Landmarks Commission

Application for Certificate of Approval Permanent Signage for Rapid Title Crain-Conklin House 9463 Montgomery Road

March 9, 2022

SPECIFICATIONS

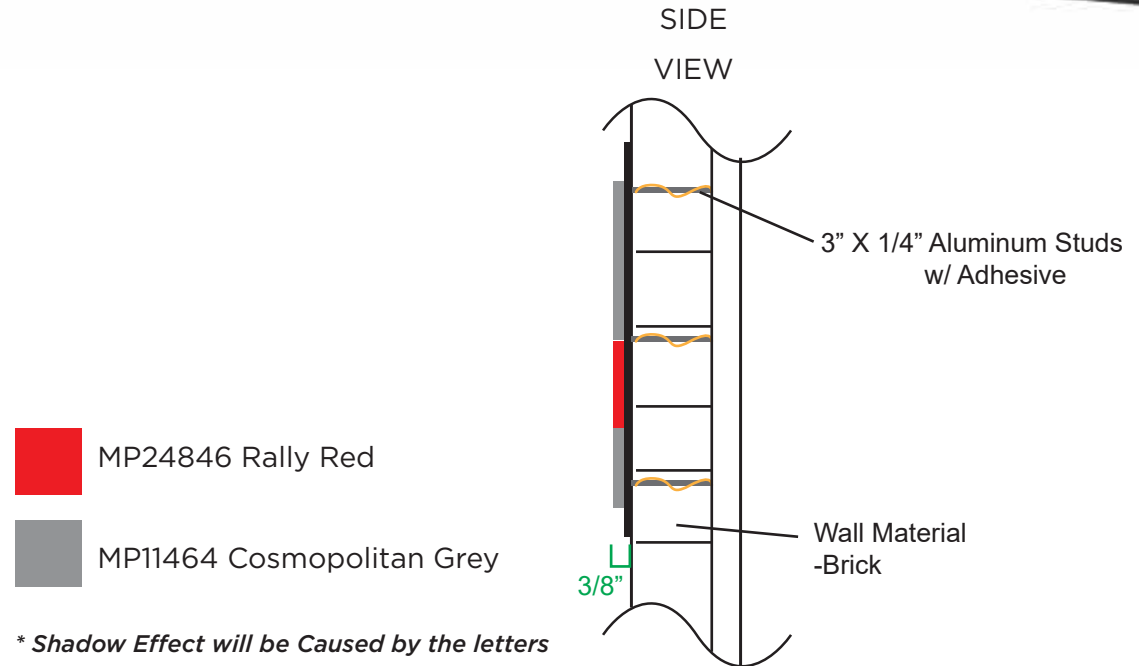
1. The applicant is proposing an 8.5 square foot sign to be mounted on the east elevation of the building.
2. The sign is proposed to be an aluminum sign with grey and red flat cut lettering.
3. The sign is proposed to be non-illuminated.

4. The sign has no more than three lines of letters and is in compliance with Chapter 151.14. The corporate logo is being utilized with the appropriateness to be determined by the Commission in accordance with 151.1405(G)(4).
5. The proposed square footage of the sign is in compliance with Chapter 151.30.
6. The location of the wall sign is in compliance with the regulations of the Zoning Code.

The design of the sign is simple and appropriate for the building. The colors and materials are in compliance with the regulations and the proposed square footage of the signs is in compliance with Chapter 151.30 and Chapter 151.14 of the Zoning Code. Should the Landmarks Commission be in support of the application, Staff would recommend a condition that the paint be a satin or matte finish.
